ADDENDUM NO.: 2  
 DATE OF CMR ADDENDUM: 01.22.2013

<b>Project Name:</b>	<b>Southern Connecticut State University Buley Library Renovation</b>
<b>Project Location:</b>	<b>New Haven, CT</b>
<b>Project Description:</b>	<b>Core &amp; Shell &amp; Fit-Out</b>
<b>Project Construction Budget:</b>	<b>20.7 Million</b>
<b>CT DCS Project Number:</b>	<b>BI-RS-225B CMR</b>

**ADDENDUM NO. 2**

**CONCRETE PAVEMENT & PRECAST PAVER CONNECTION**

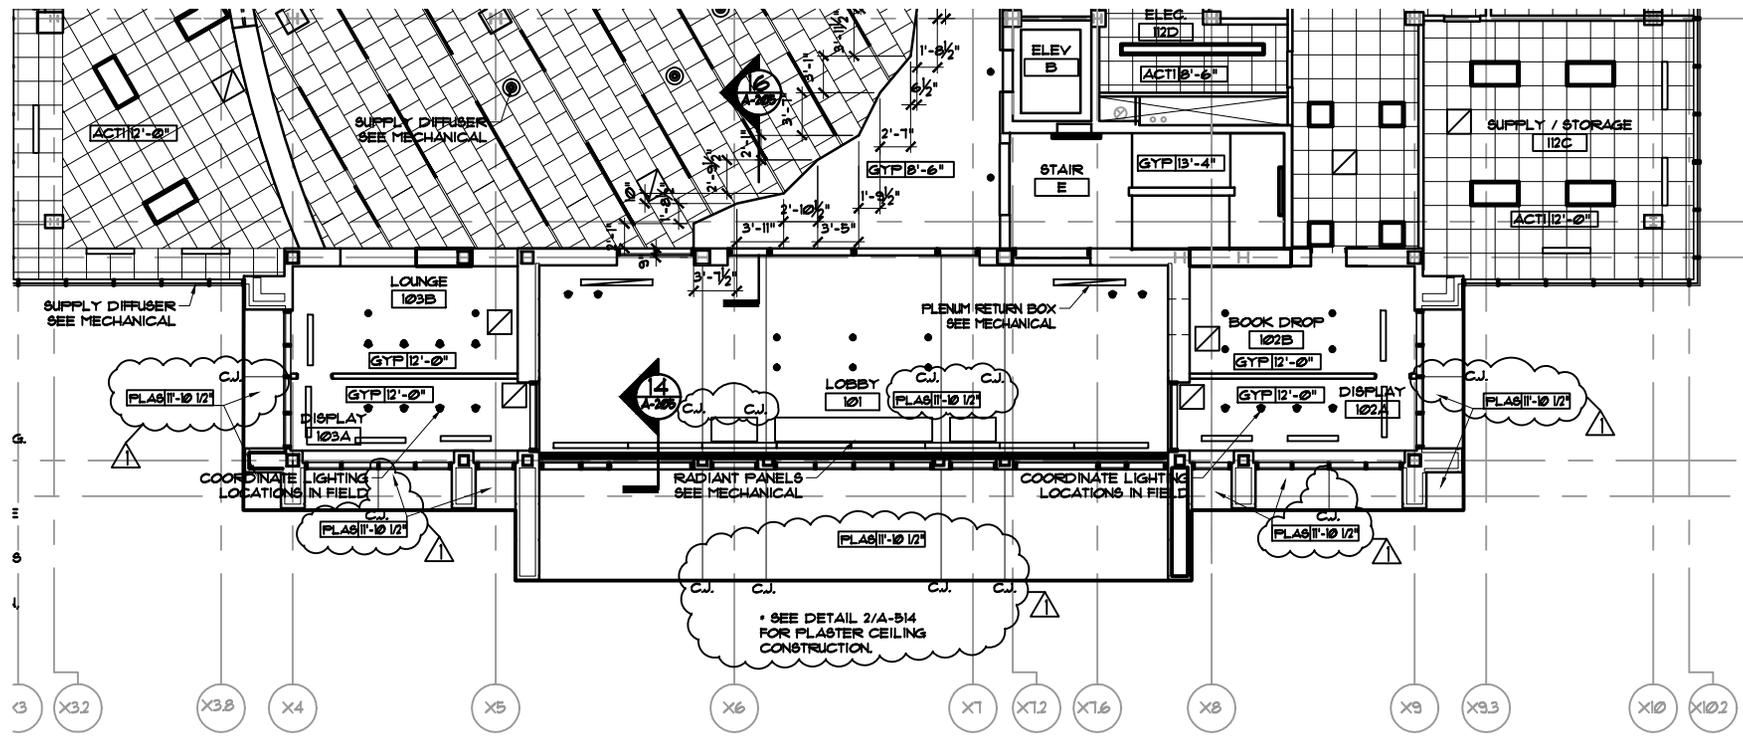
6. Incorporate SCSU Buley Library Sketch Log with associated sketches issued via Addendum #2 as follows:
  - a. B-SKL-01 Added Site Plan Detail
  - b. B-SKA-01 Plaster Ceiling

**1 FIRST FLOOR REFLECTED CEILING PLAN**  
 BKA-01 1/16"=1'-0"

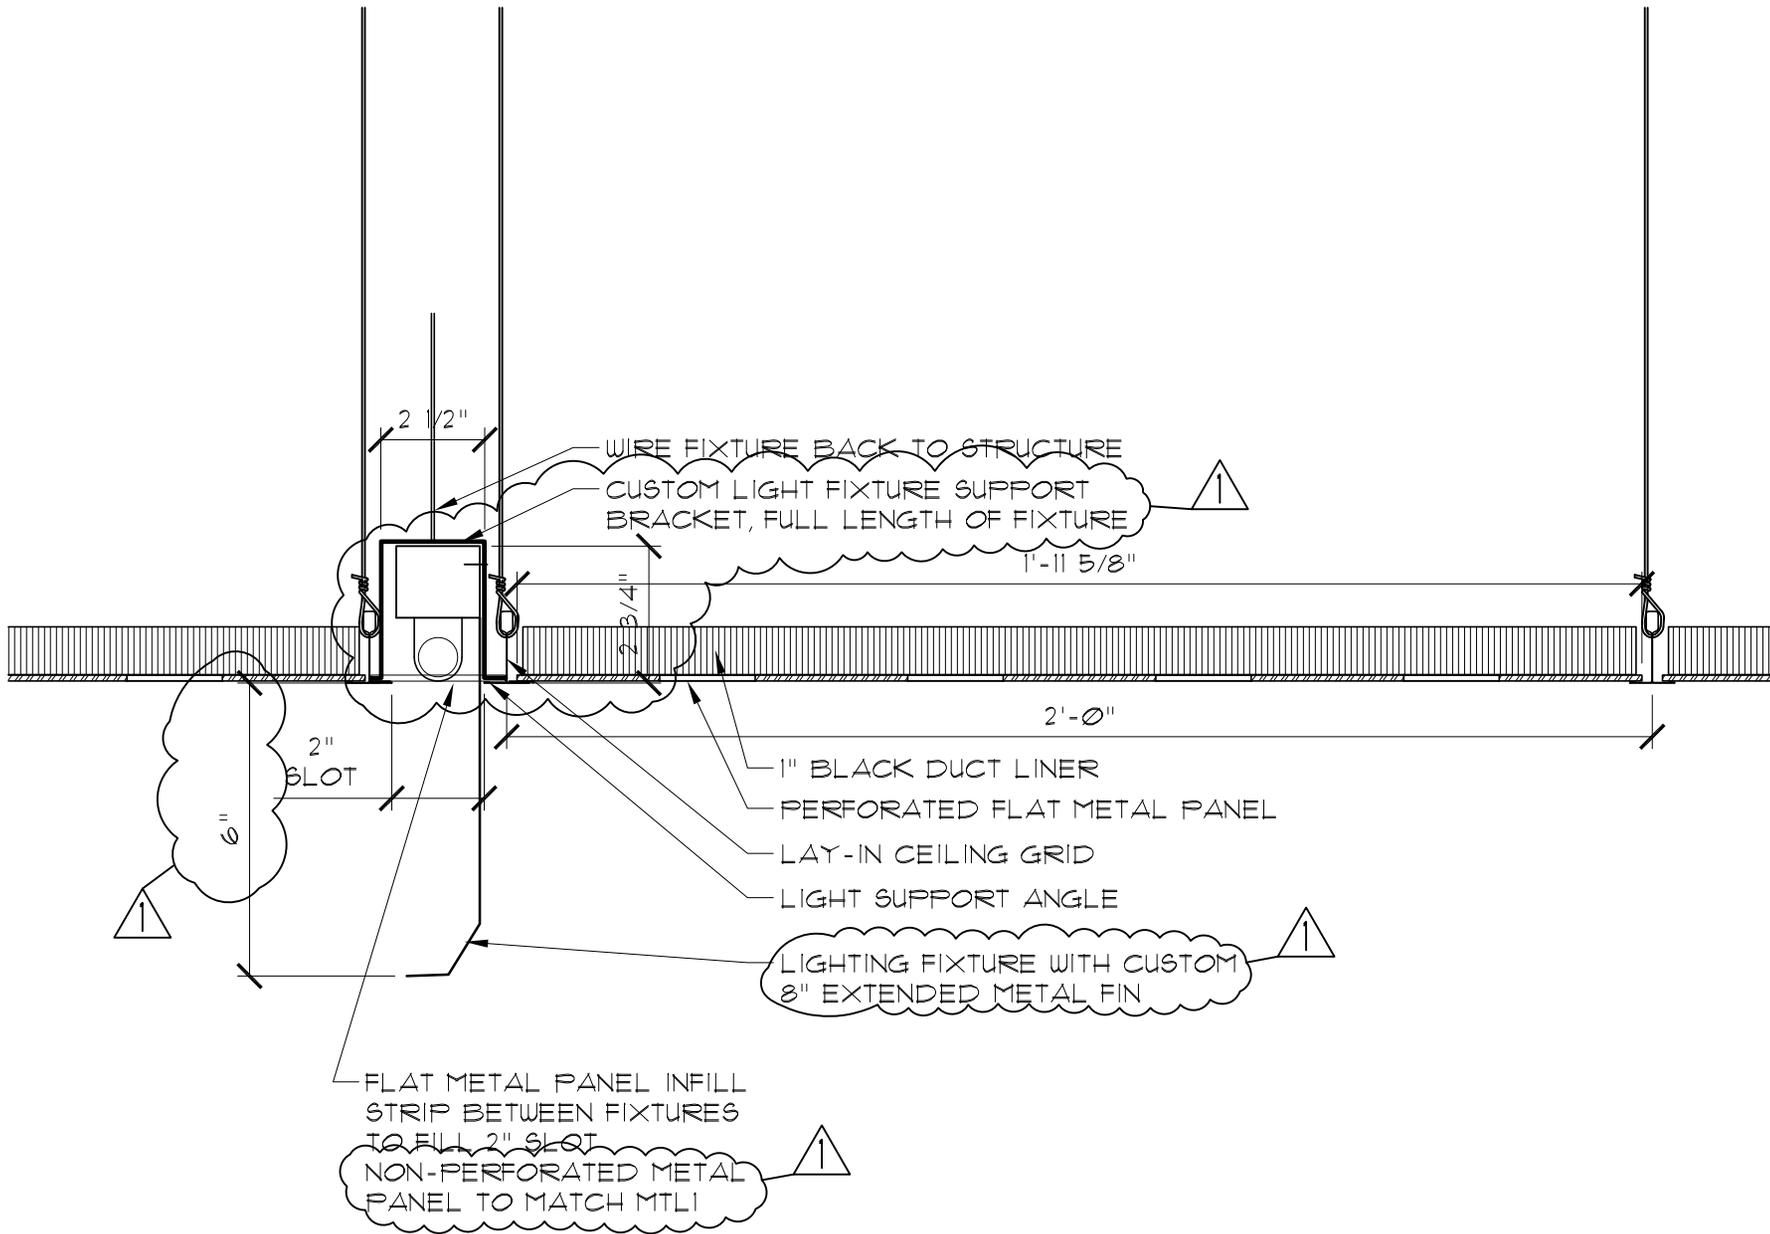
- A. 3/4" thick, 3 Coat Metal Lath and Plaster System on suspended metal carrying channels meeting minimum recommended requirements of USG 3 coat metal lath and plaster system. All materials for system shall be by one manufacturer.
- B. Metal Lath: Galvanized, small diamond mesh, self furring, metal lath for ceilings 3.4lb. / sq. yd.
- C. Scratch and Brown Coat Plasters: USG Structo-Base Gypsum Plaster.
- D. Finish Coat Plaster: USG Structo-Gauge Gauging Plaster.
- E. Accessories: USG Accessories as detailed in drawings and to provide a complete 3 coat metal lath and plaster system.

\*\*WATER HEATER SCHEDULE REVISIONS\*\*  
**BULEY LIBRARY RENOVATIONS**  
 SOUTHERN CONNECTICUT STATE UNIVERSITY  
 NEW HAVEN, CONNECTICUT  
 Project No. BL-RS-225B

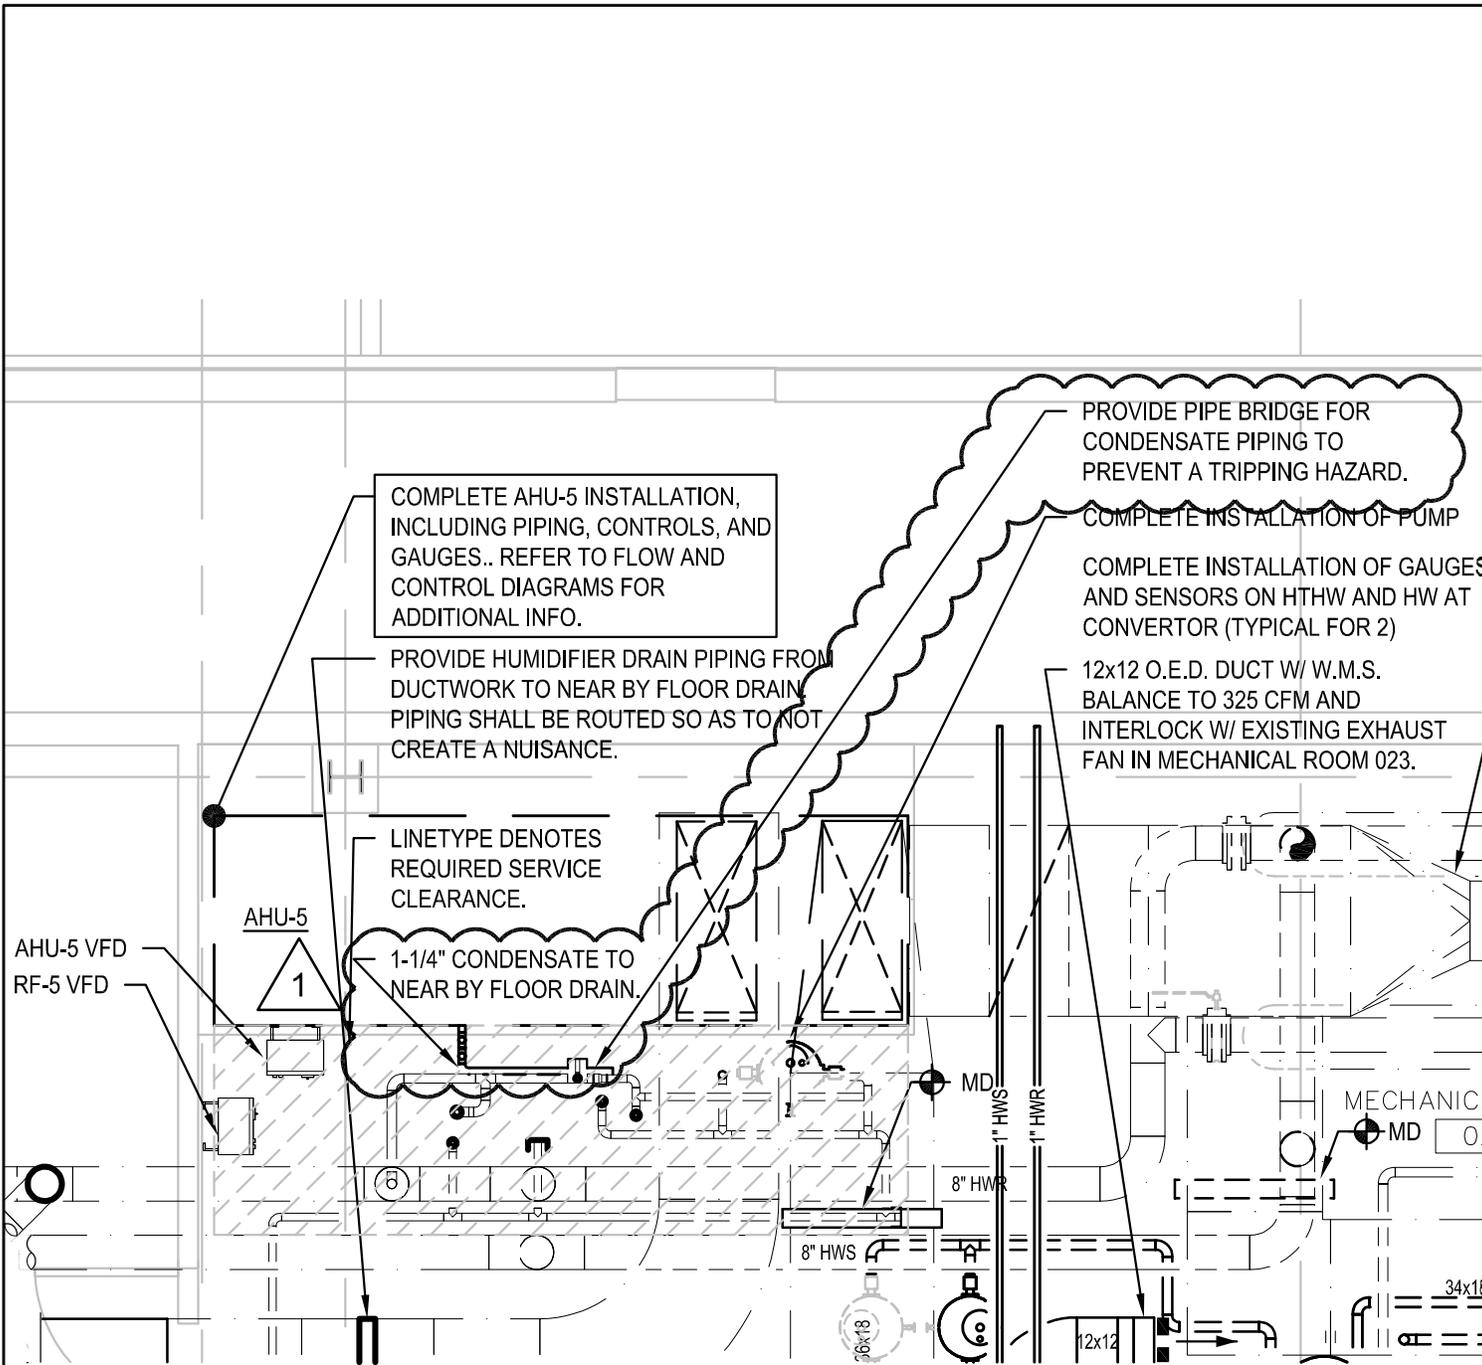
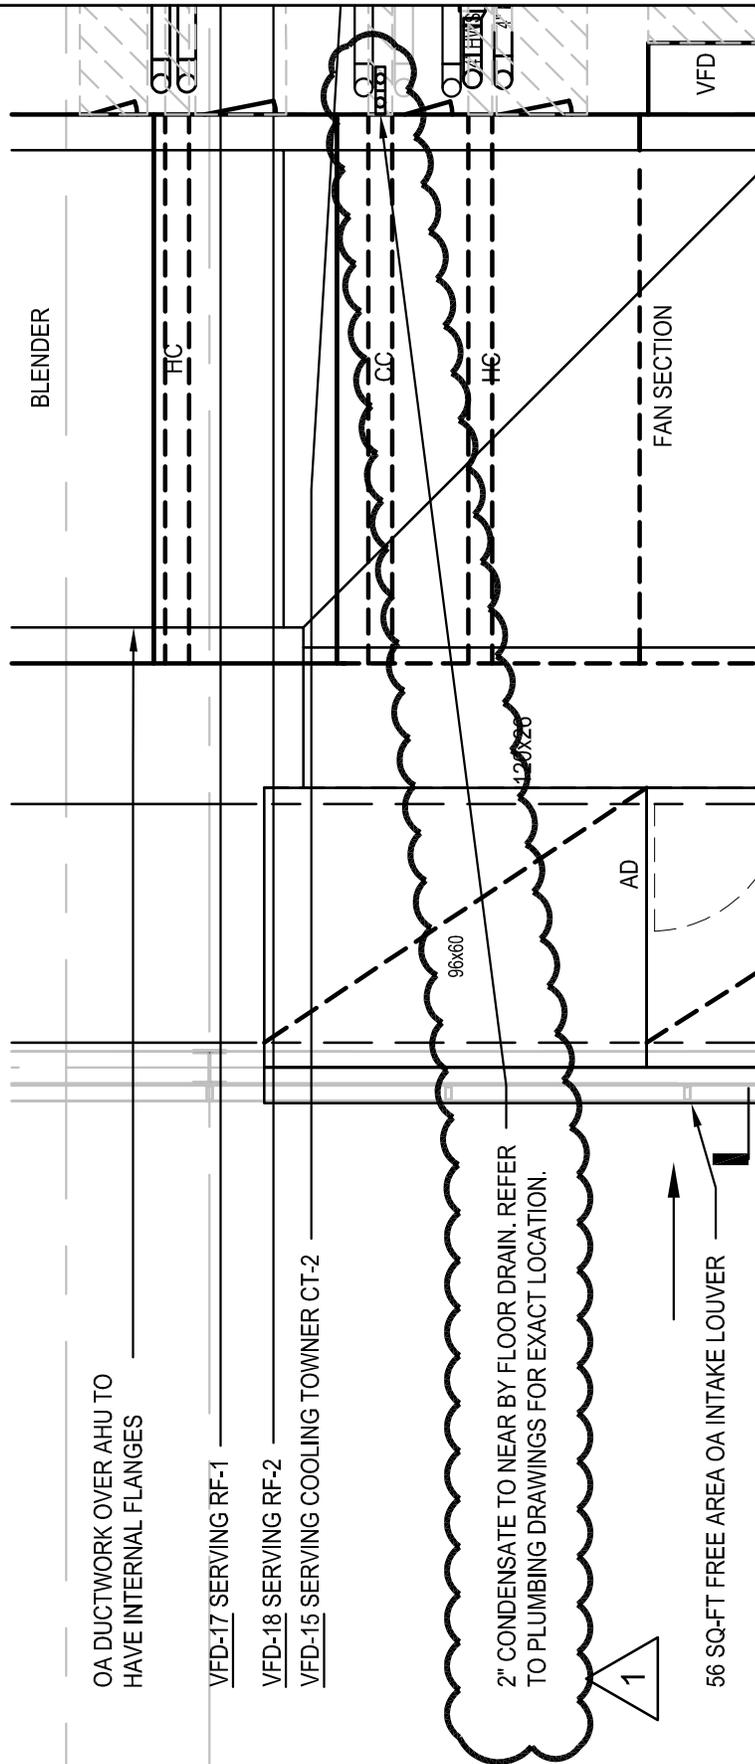
GROUND FLOOR/FIRST FLOOR: WH1&WH2: EXPANSION TANKS (2-EXP-1's) MODEL AMTROL THERM-X-TROL, ST-5-C, ASME, 2.1 GALLON CAPACITY THERMOSTATIC MIXING VALVE: (TMV-1 & TMV-2) SYMMONS TEMPCONTROL MODEL NO. 6-200-A-RC  
 SECOND FLOOR: WH3: EXPANSION TANK (EXP-1) MODEL AMTROL THERM-X-TROL, ST-12-C, ASME, 6.4 GALLON CAPACITY THERMOSTATIC MIXING VALVE: (TMV-3) SYMMONS TEMPCONTROL MODEL NO. 6-400-A-RC  
 3RD FLOOR (WH4) & 4TH FLOORS (WH5 & WH6): FOR S1 APPLICATIONS ONLY

AHU-1 CONDENSATE PIPING  
**BULEY LIBRARY RENOVATIONS**  
 SOUTHERN CONNECTICUT STATE UNIVERSITY  
 NEW HAVEN, CONNECTICUT  
 Project No. BI-RS-225B

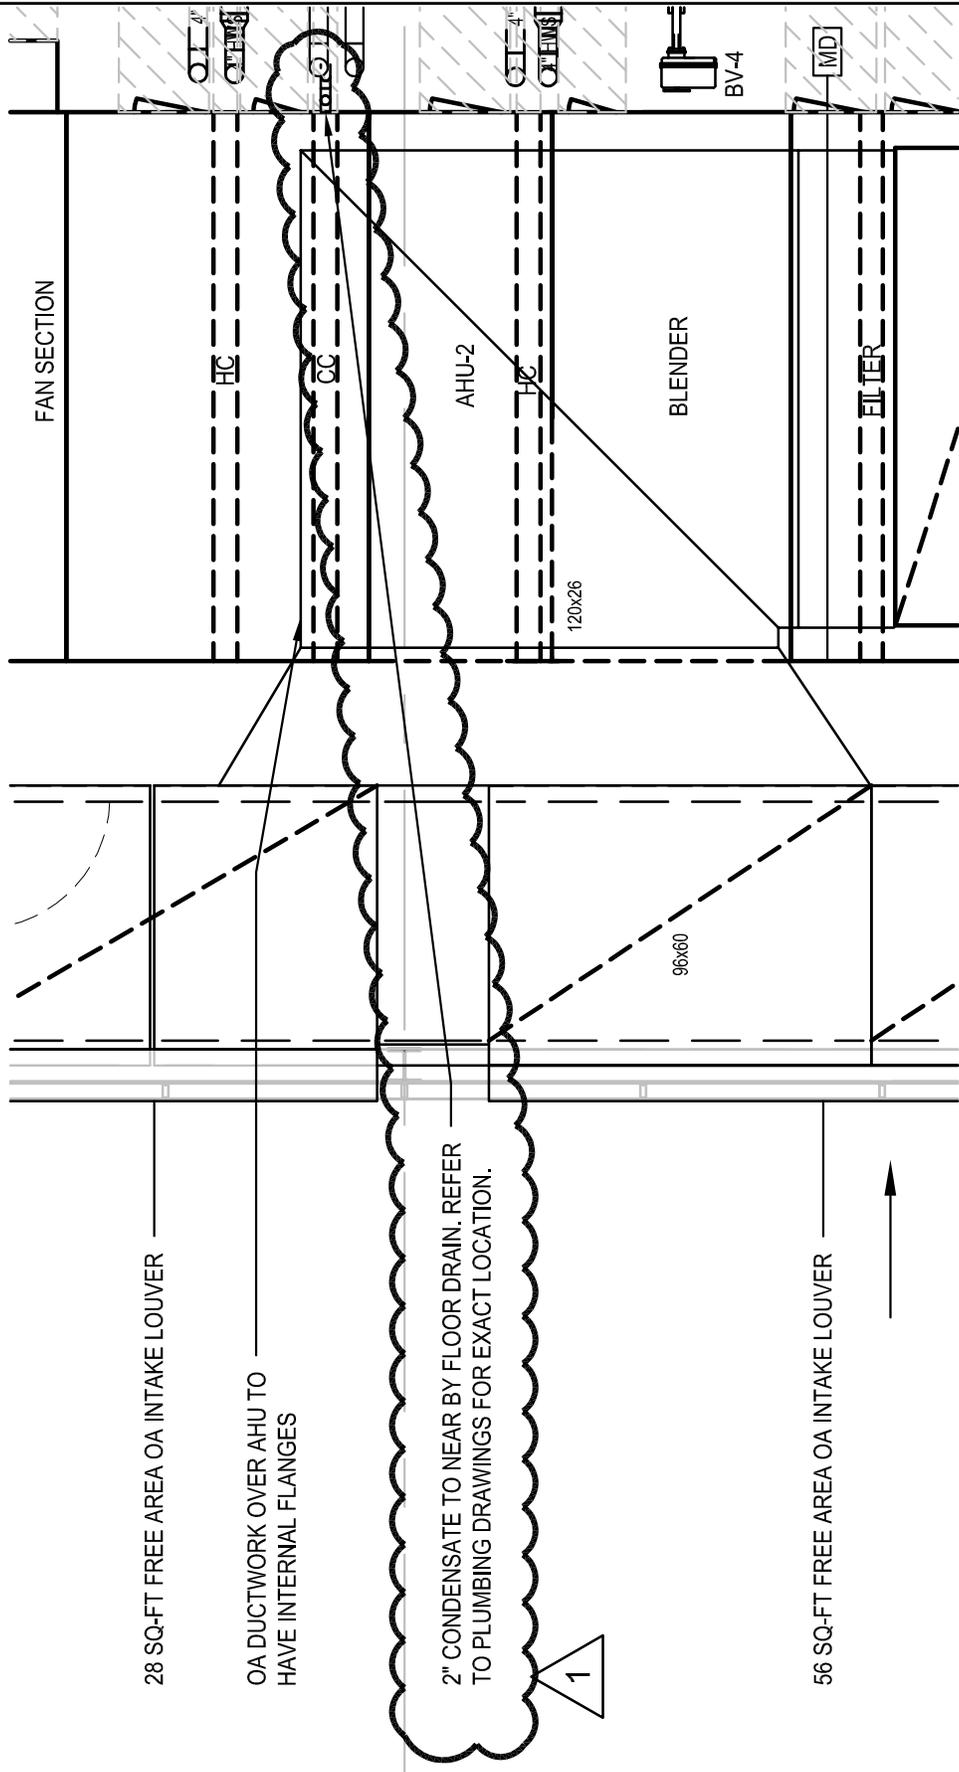
1. ADD Item #103- "This subcontractor shall provide condensate drain piping from all air handlers to local floor drains in the associated mechanical rooms they reside per the mechanical schedules on M-300."
2. ADD Item #104- "This subcontractor shall be responsible for the removal and proper disposal of the existing chiller CH-2 located in mechanical room 205. Removal includes rigging and removal through the existing areaway."
3. ADD Item #105- "This subcontractor shall be responsible for the modification or addition to the refrigerant detection system, and shall provide refrigerant detection for both the existing chiller CH-1 and the new chiller CH-2 installation."
4. ADD Item #106- "This subcontractor shall assume that all wiring is plenum rated regardless of whether or not it is shown on the contract documents."
